PEER REVIEW REPORT

**PETERBOROUGH MEMORIAL CENTRE  
STRUCTURAL REVIEW**

C018.2148

FOR: CITY OF PETERBOROUGH | DATE: NOVEMBER 9, 2018

**Photograph 9 | Spalled and Delaminated Concrete located towards the Top of the North Foundation Wall in the Brine Trench**

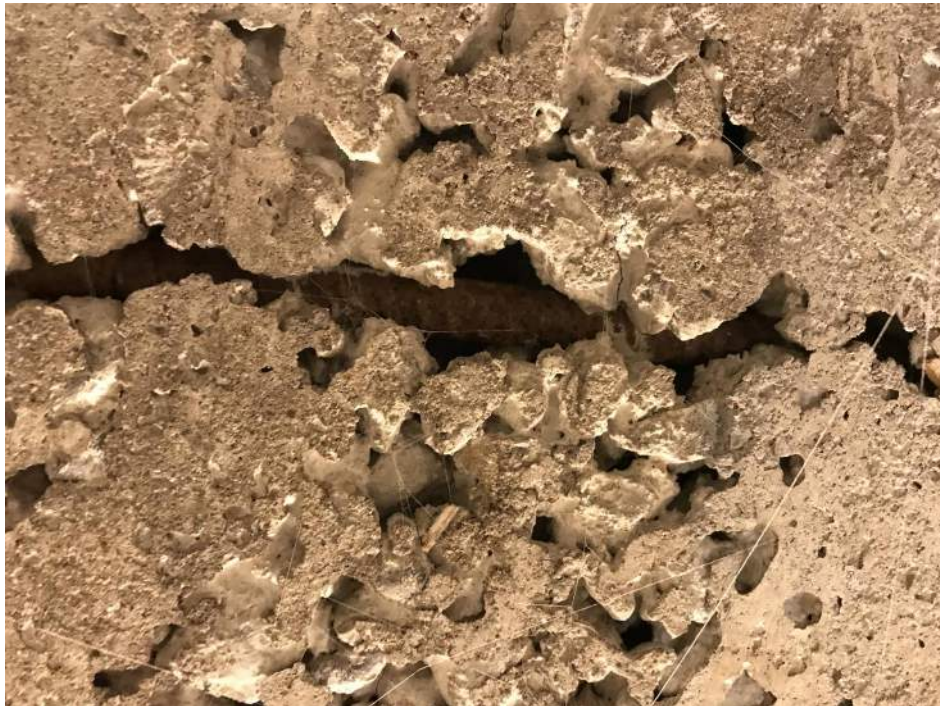
1. The north brine trench concrete foundation wall (Gridline 4x as noted on S-2 in the 2002 drawings) adjacent to the brine header pipes at the south end of the rink (beneath the dasher boards) was observed to be in poor condition. Entuitive's access at the time of review was limited to the south face of the wall since the crawlspace to the north of the wall had backfilled. Concrete deterioration was observed across the full length of the wall. Areas of cracking, freeze-thaw damage, spalling, and deteriorated concrete were observed, in addition to staining from corroding steel and water leaching. The condition of the top of the wall was not visible at the time of review due to the ice build-up around the brine header and feeder pipes. The condition of the concrete at the lower portions of the wall appeared to be sound, as was indicated in CSE's South Supporting Wall Delamination Survey Drawings SK1-01, dated July 12, 2017. See photographs 8 and 9.

1. The north concrete foundation wall beneath the dasher boards at the south of the ice rink was observed to be in poor condition and is a structural concern. Based on our field observations and our review of the existing drawings and the investigation reports we recommend that steps be taken as soon as possible to provide additional support to the original rink slab within the brine trench for the full extent of the north brine trench foundation wall.

2. Given the extent of the wall deterioration observed and the limited accessibility to the north side of the foundation wall, it is our opinion, that the wall structure supporting the slabs cannot be effectively repaired with localized concrete wall repairs. A full replacement of the deteriorated foundation wall will come with the risk of damaging the current brine system and impacting the usefulness of the facility for both sports teams.

3. In lieu of a concrete wall repair procedure, it is our recommendation that a steel frame support system be installed to transfer the load from the slab to sound concrete at the bottom portion of the existing foundation wall and footing. A sketch detailing a proposed steel frame support system is included as drawing SK03 in Appendix B. The proposed steel framing will have to be installed during the summer months when ice buildup is not present on the brine header and feeder pipes. The existing slab will bear on steel sections that run perpendicular (north-south) to the trench foundation walls. These steel sections will have a slim profile and will be spaced to accommodate the brine headers and feeder pipes to ensure that the existing brine system is not modified during the work or after the work has been complete.

**Photograph 13 | Corroded Cast-In Angle on the Underside of the Existing Suspended Slab adjacent to the North Foundation Wall in the Brine Trench**

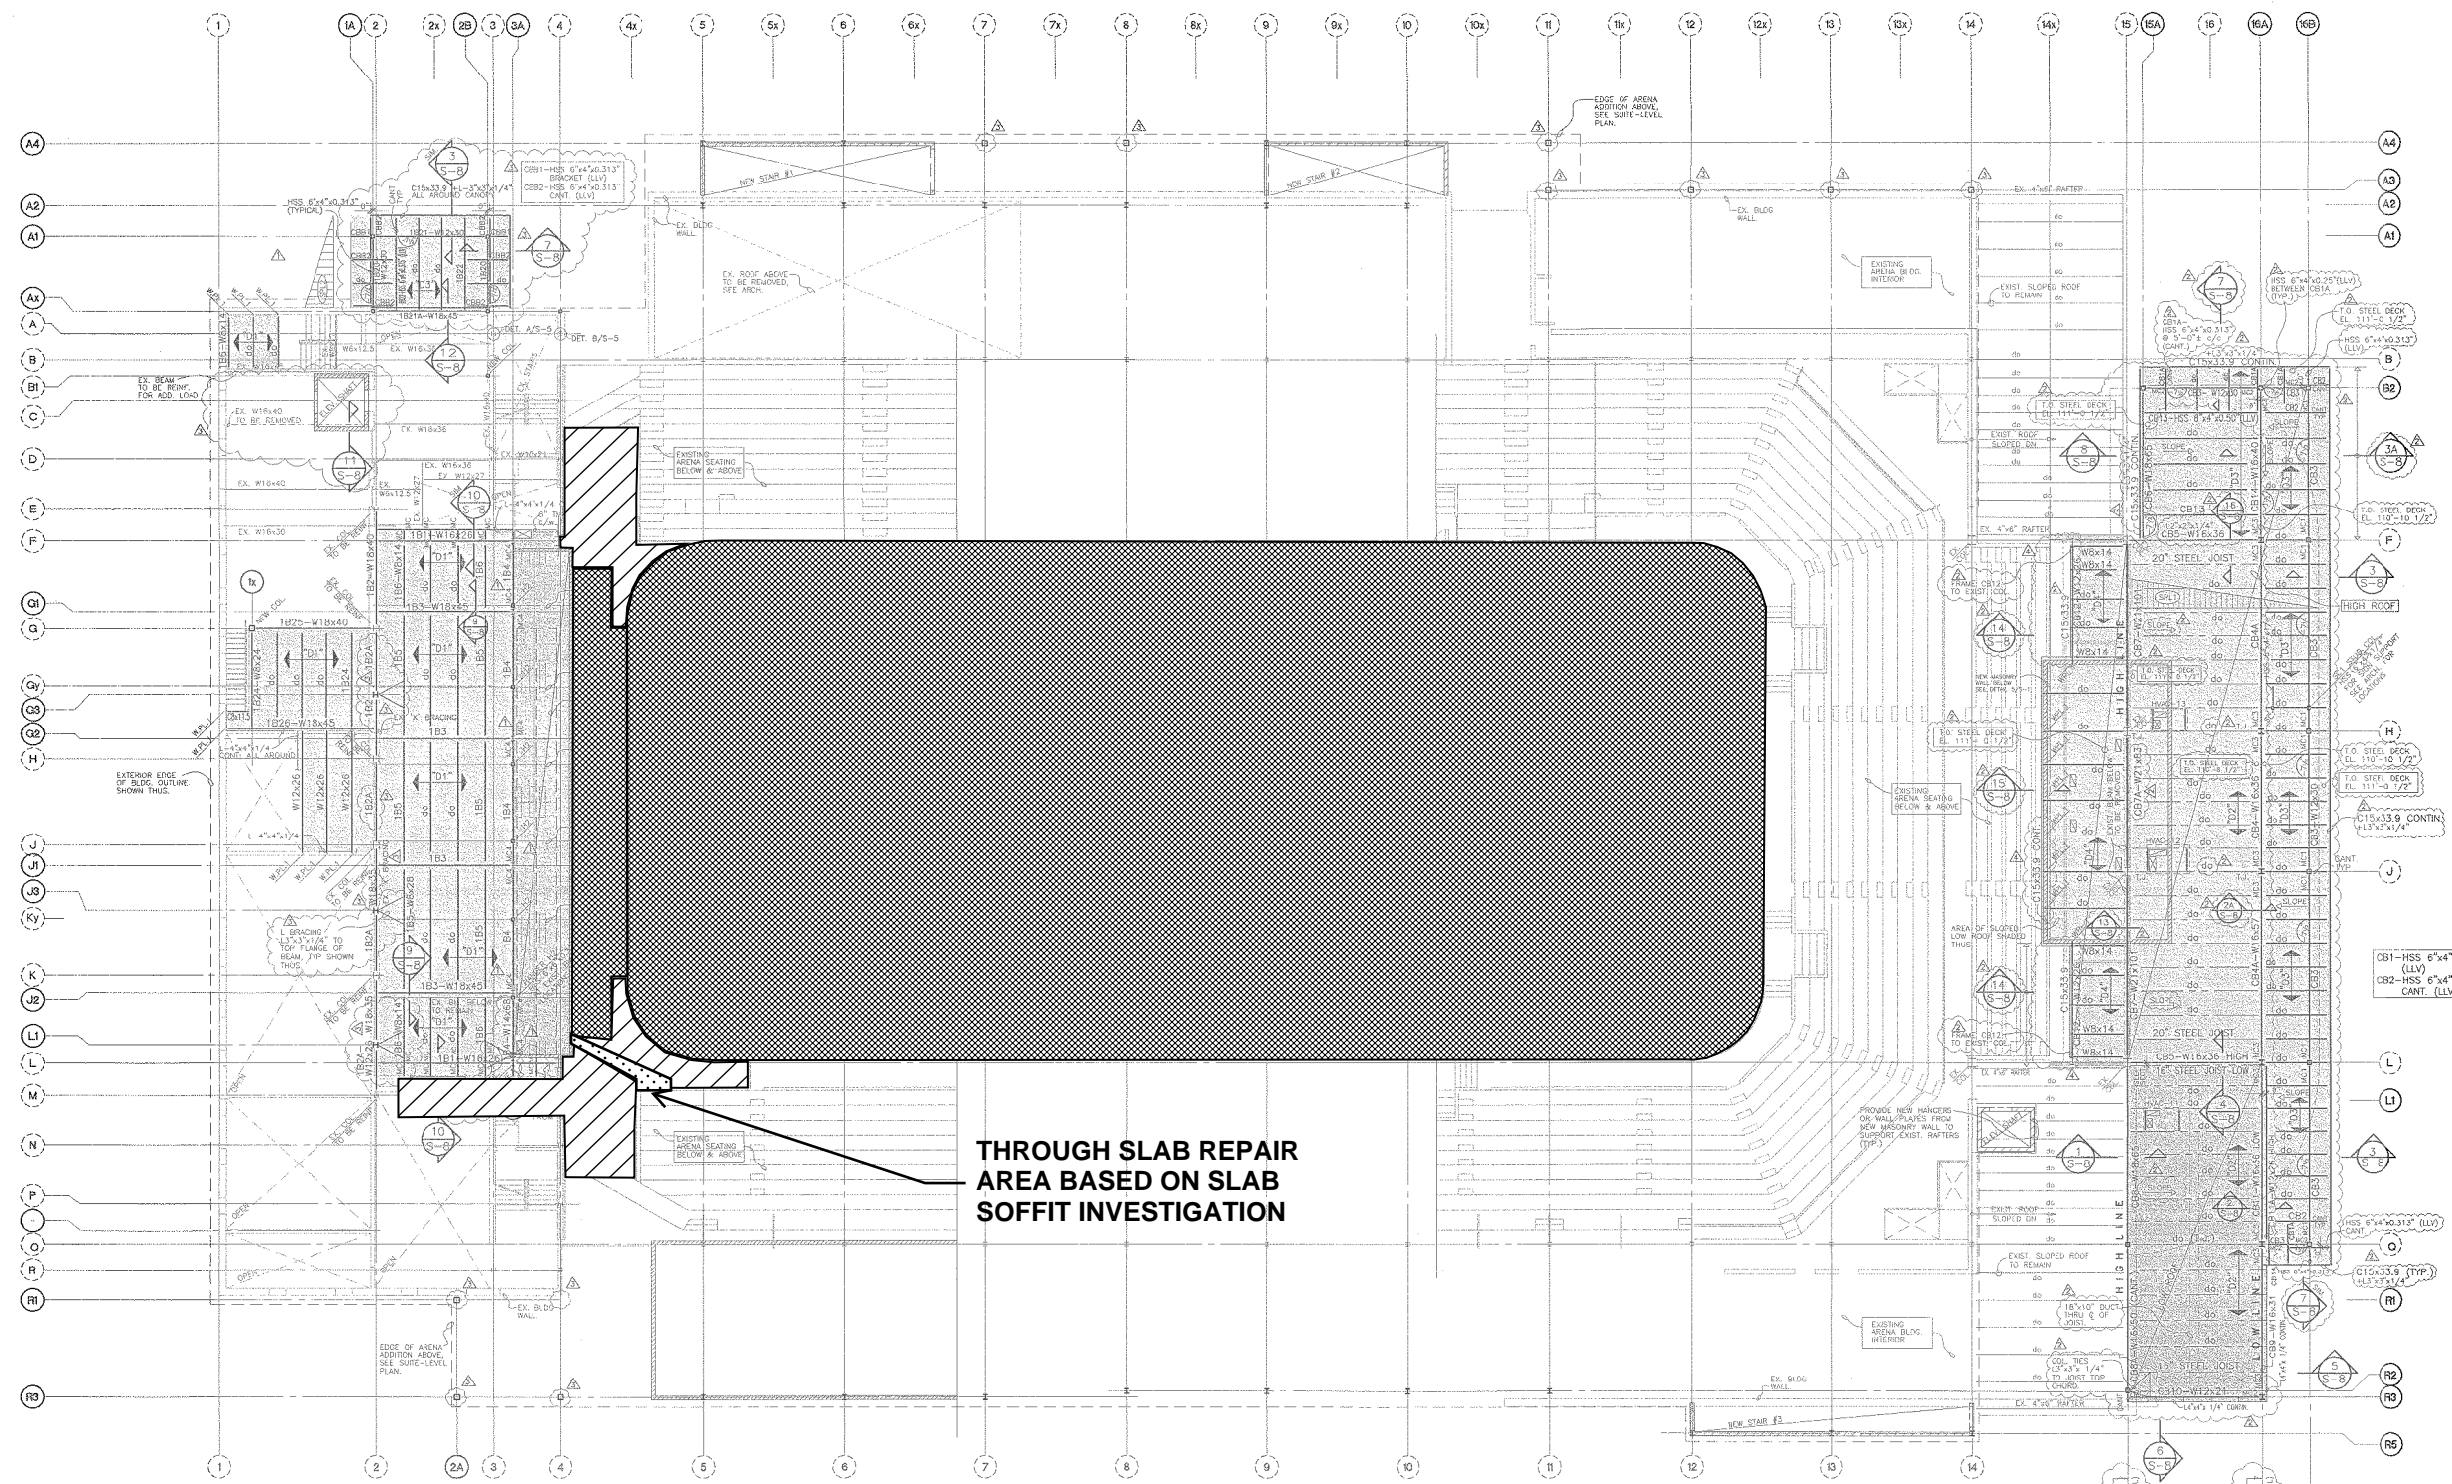
4. The condition of the underside (soffit) of the existing slab directly above the brine header and feeder pipes adjacent to the north brine trench foundation wall was not visible at the time of review. The build-up of ice around the pipes at this location made the underside (soffit) of the slab inaccessible. However, wooden formwork was observed on the underside of the slab at the locations where the feeder pipe penetrated the slab, as per CSE's structural updated report dated July 3, 2018. Where visible, the existing cast-in angle on the underside (soffit) of the suspended slab was observed to be severely

corroded. Honeycombed concrete and exposed corroded reinforcing steel were observed at these locations. See photographs 13 and 14.

SK01 - PMC - TOPSIDE INVESTIGATION PLAN

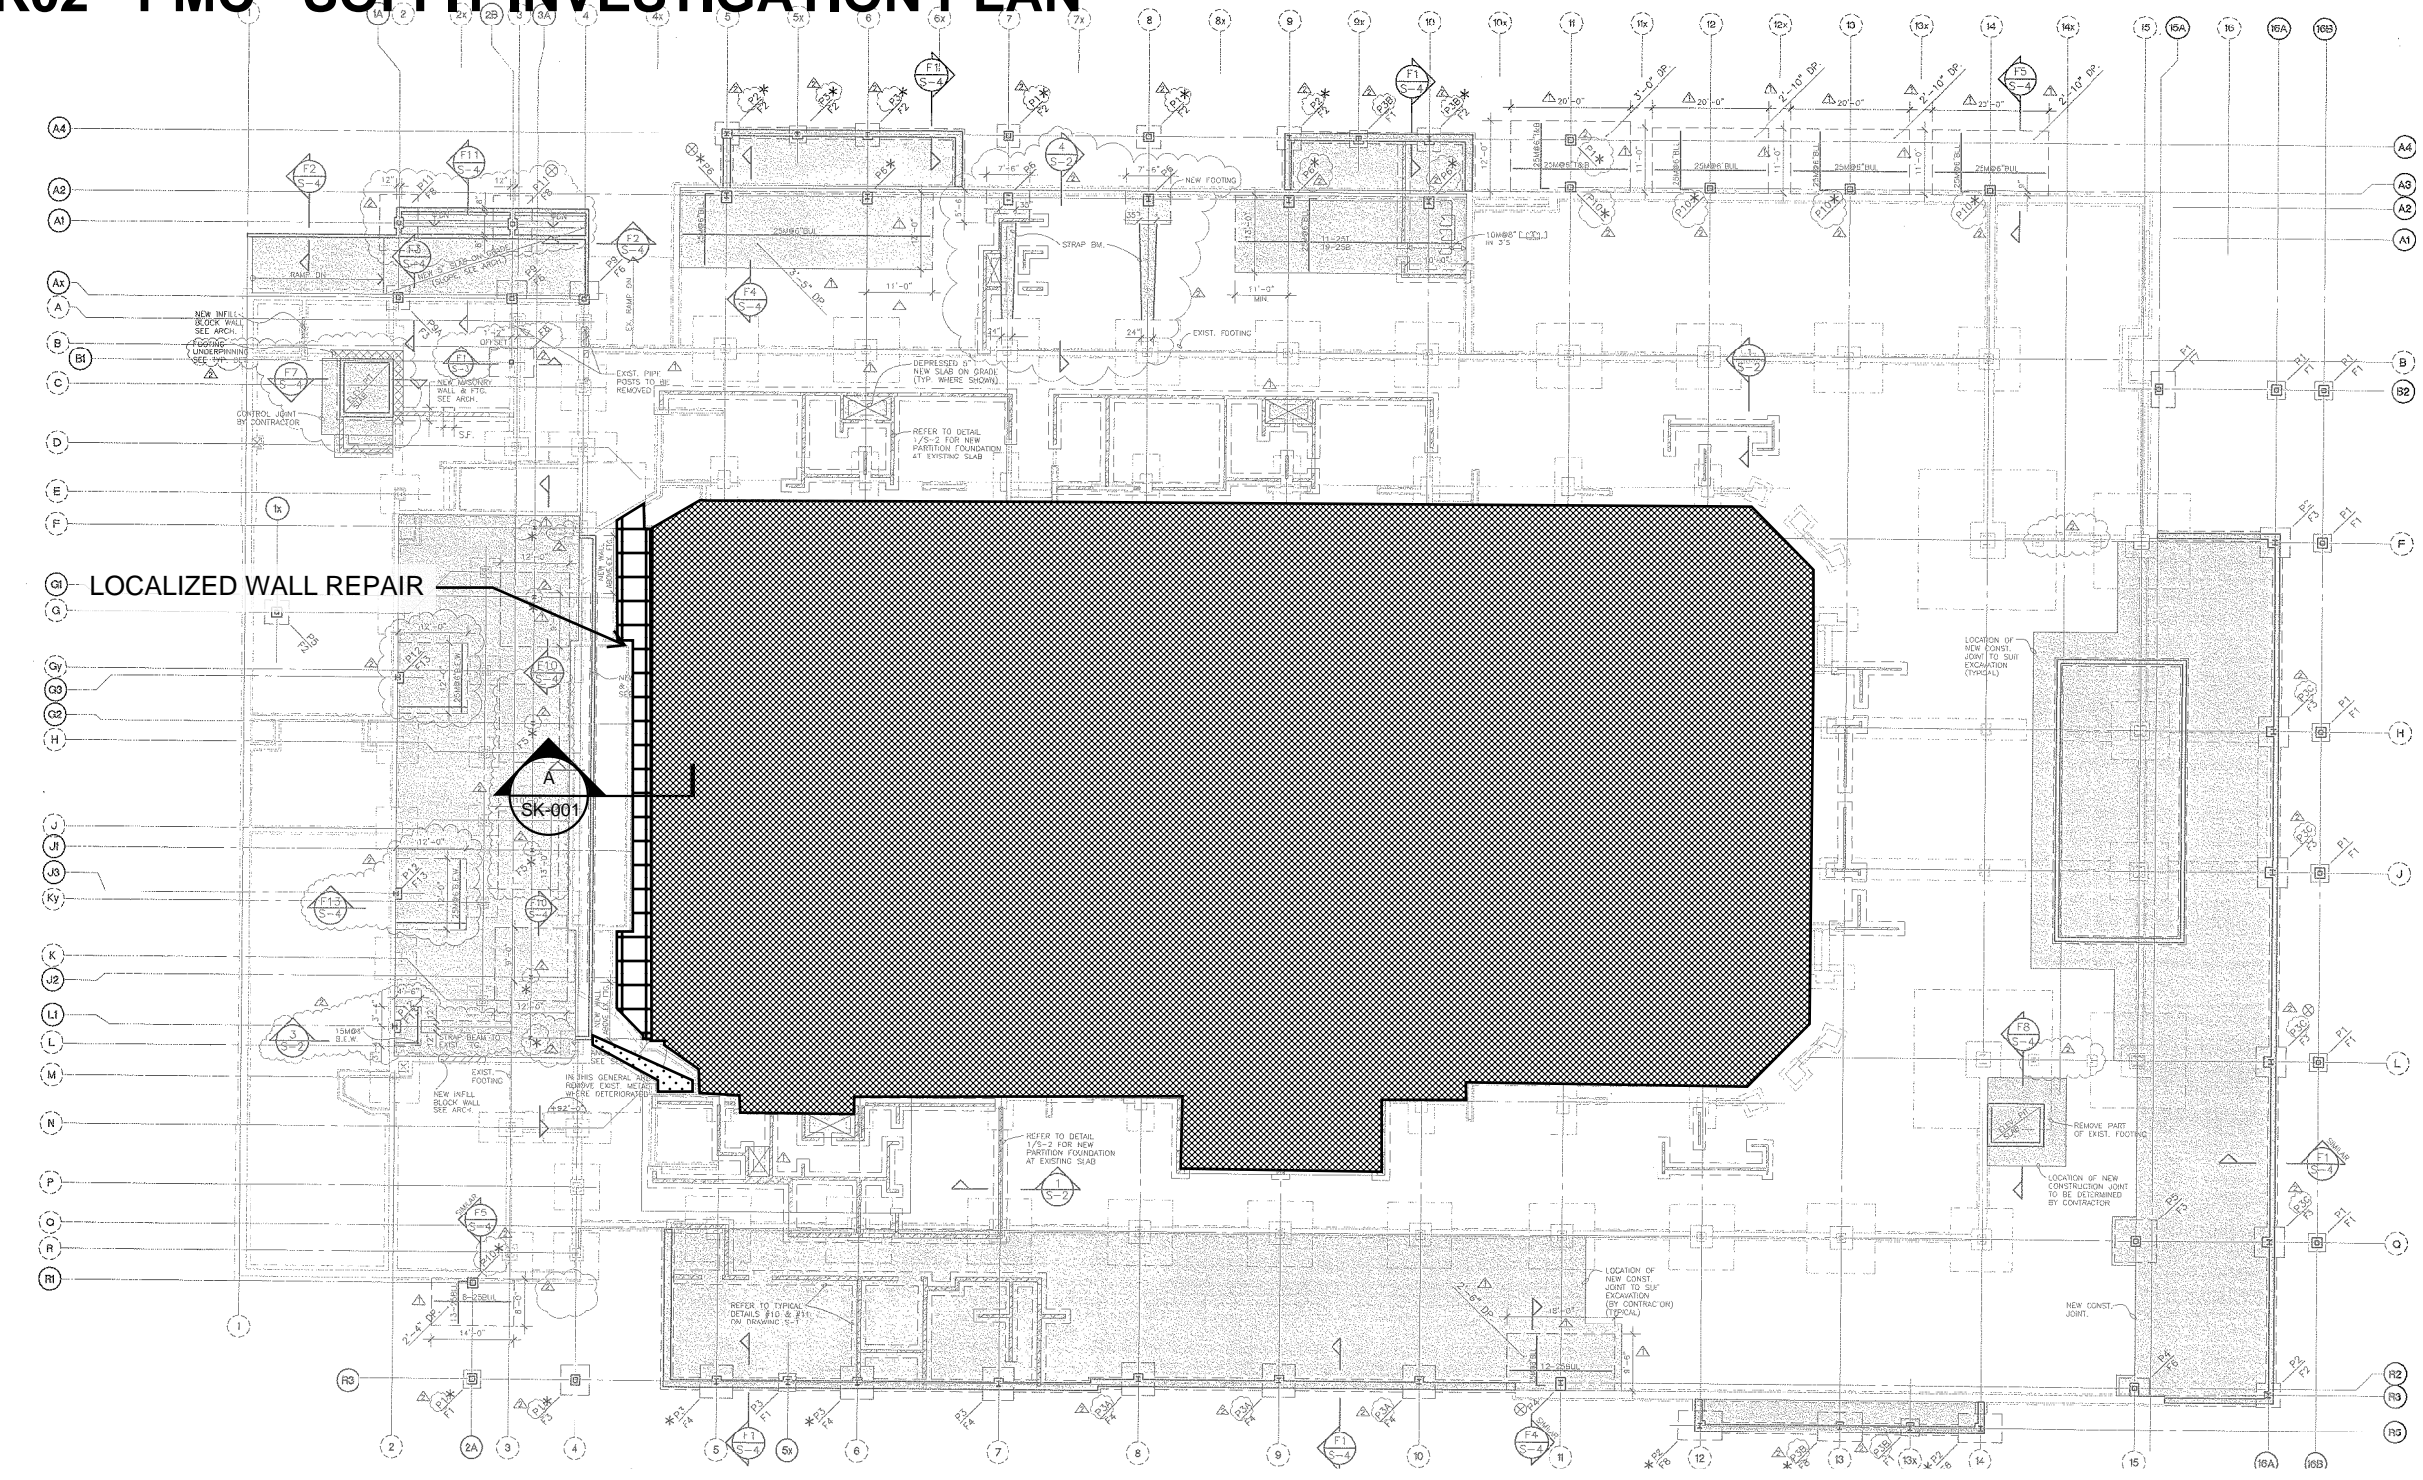
3. Based on our visual observations and our review of the existing drawings and the investigation reports to date, the condition of the suspended concrete slab beneath the ice resurfacers path at the southeast corner of the ice rink is in poor structural condition and should be repaired. Extensive cracking, delamination and spalling of the underside (soffit) of the original 1955 rink slab was observed, and wide cracks were observed on the topside of the 1979 topping slab directly above this deteriorated area. We recommend that through slab concrete repairs be completed in this location as soon as possible. Given that this area is outside the ice rink area, the repairs can be done in the hockey offseason while still providing continued access to the rink slab during the lacrosse season. Drawing SK01 & SK02 in Appendix B indicate the area of the recommended through slab repair.

1. Based on our visual observations, the condition of the topping slab generally appeared to be in fair condition, with minor localized cracking and delamination. Deteriorated areas of the topping slab warrant localized repairs to mitigate further deterioration. Localized repairs to the topping slab will provide longevity to the topping slab and to original rink slab beneath. We recommend that localized repairs be performed within 3 to 4 years.
